Summary of Amendments to the Design Manual: Barrier Free Access 2008 (June 2019)

Amendments to the Design Manual: Barrier Free Access 2008

(June 2019)

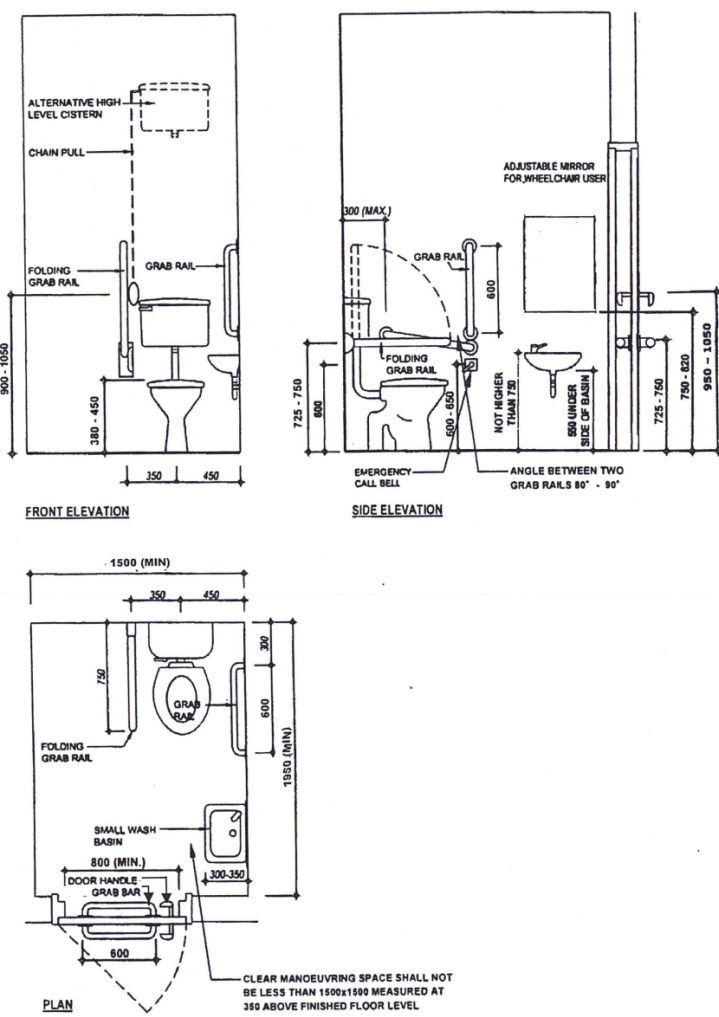
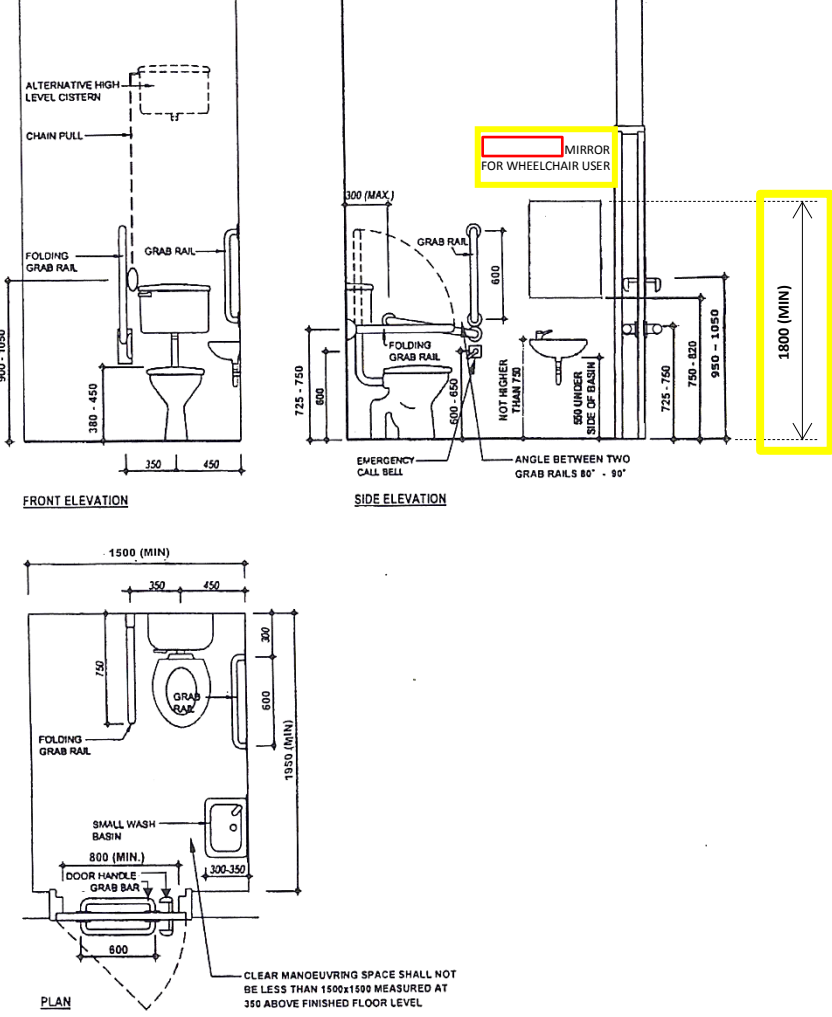
Item	2012 version	Amendments
<p>12. Figure 24 in Division 11 of Chapter 4*</p>	 <p>FRONT ELEVATION</p> <p>SIDE ELEVATION</p> <p>PLAN</p> <p>*ALL DIMENSIONS ARE IN mm DIMENSIONS PRINTED IN BOLD FORM DENOTE OBLIGATORY REQUIREMENT DIMENSIONS PRINTED IN ITALIC FORM DENOTE RECOMMENDED REQUIREMENT</p> <p>(Opposite - Handed Layout is Acceptable)</p> <p>Figure 24 – Accessible Toilet</p>	 <p>FRONT ELEVATION</p> <p>SIDE ELEVATION</p> <p>PLAN</p> <p>*ALL DIMENSIONS ARE IN mm DIMENSIONS PRINTED IN BOLD FORM DENOTE OBLIGATORY REQUIREMENT DIMENSIONS PRINTED IN ITALIC FORM DENOTE RECOMMENDED REQUIREMENT</p> <p>(Opposite - Handed Layout is Acceptable)</p> <p>Figure 24 – Accessible Toilet</p>
